Our reference: 856489 Latchmere Construction

## ECOLOGICAL ASSESSMENT FOR LATCHMERE TEMPORARY MARKETING SUITE

We have reviewed the final agreed plans for the temporary marketing suite at Latchmere House, Ham Common, Richmond, Surrey, (Ordnance Survey Grid Reference TQ 184 172) and we are pleased to see that our suggestions have been incorporated. Our assessment is outlined below.

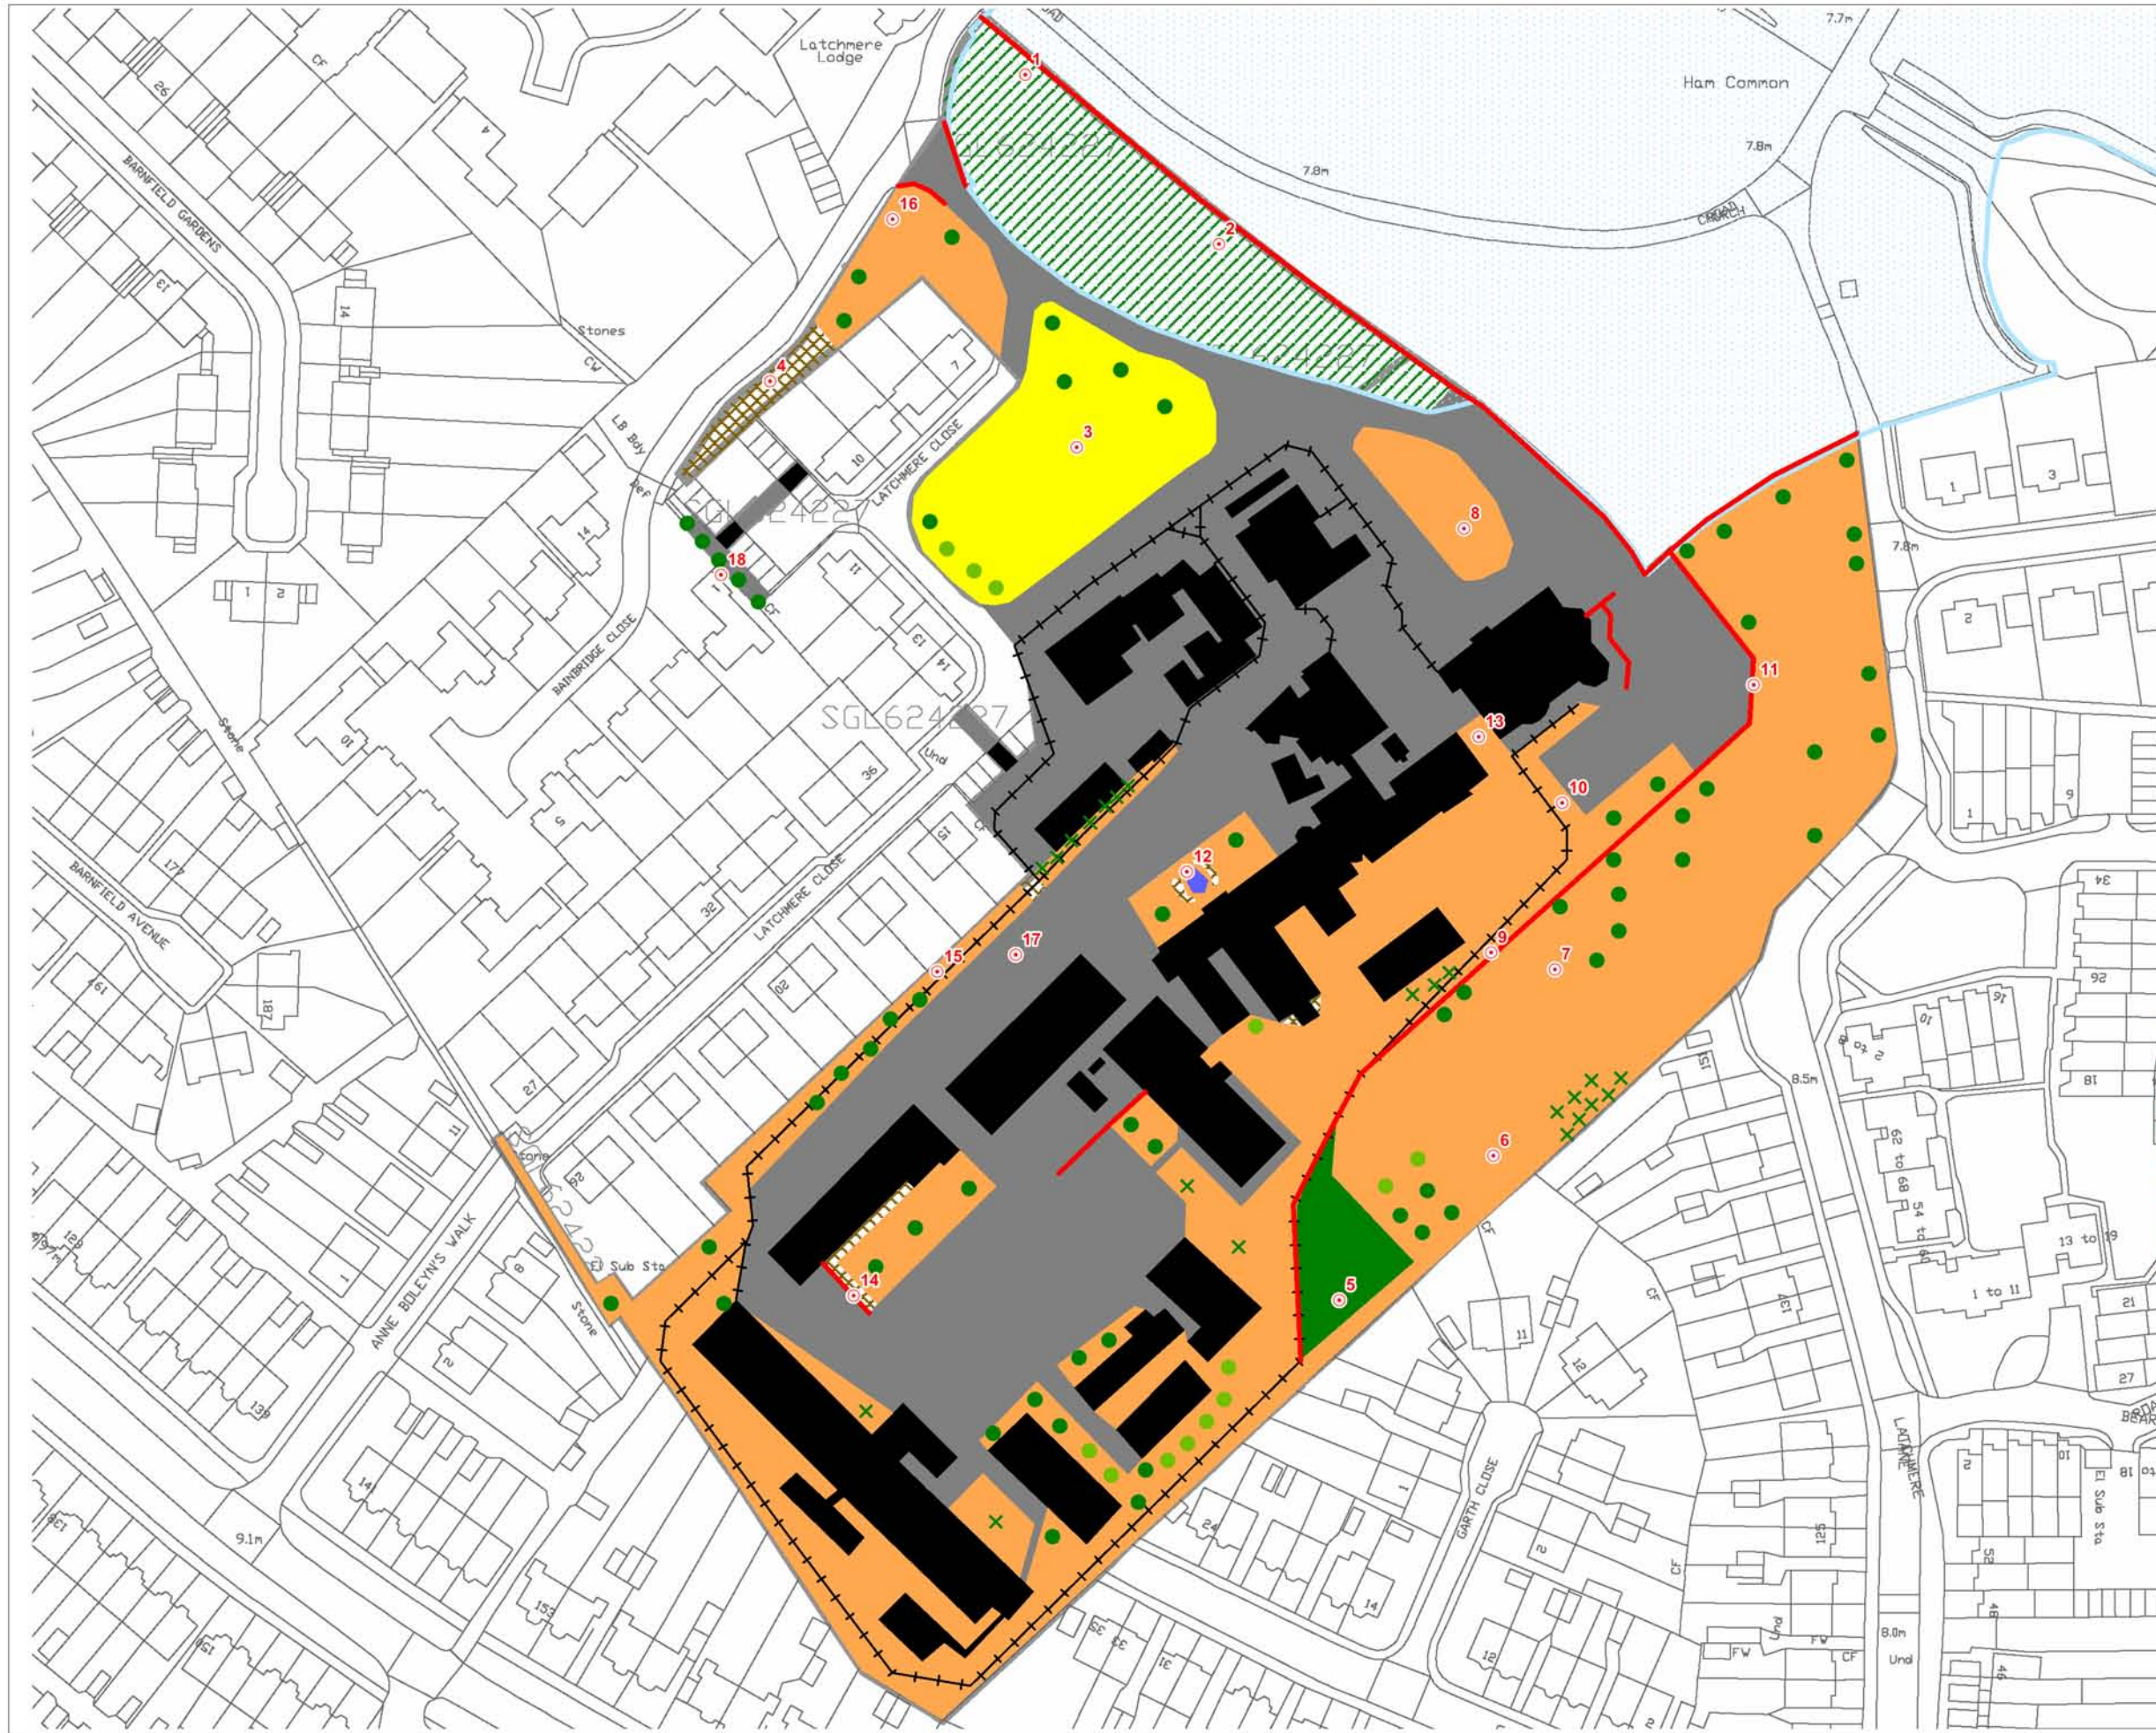
We have reviewed the proposed lighting plan and reduced lighting where possible including eliminating lighting in an area directly adjacent to one of the four trees with compensatory bat boxes (tree reference T42). We are not required to monitor these boxes to check for the presence of roosting bats (i.e. as a condition of the granted EPS licence) therefore this approach is precautionary but will also aid future colonisation of the bat boxes during the period of time that the marketing suite is in use.

We are content that the current lighting plan minimises any potential for negative impacts to roosting, foraging and commuting bats. There is an existing level of street lighting in this area and all measures have been taken to minimise any cumulative impact associated with lighting of the proposed temporary marking suite.

Figure 2  
Botanical Phase 1  
SCALE: 1:1,250 @ A3  
REV 00

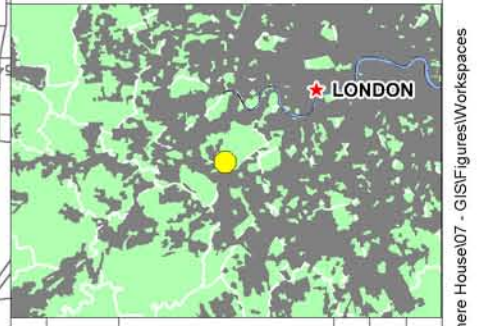
The area is shown on the attached phase 1 habitat map as *Target Note 2* (this figure is taken from the original phase 1 habitat report submitted with the planning application for the main site). It was not
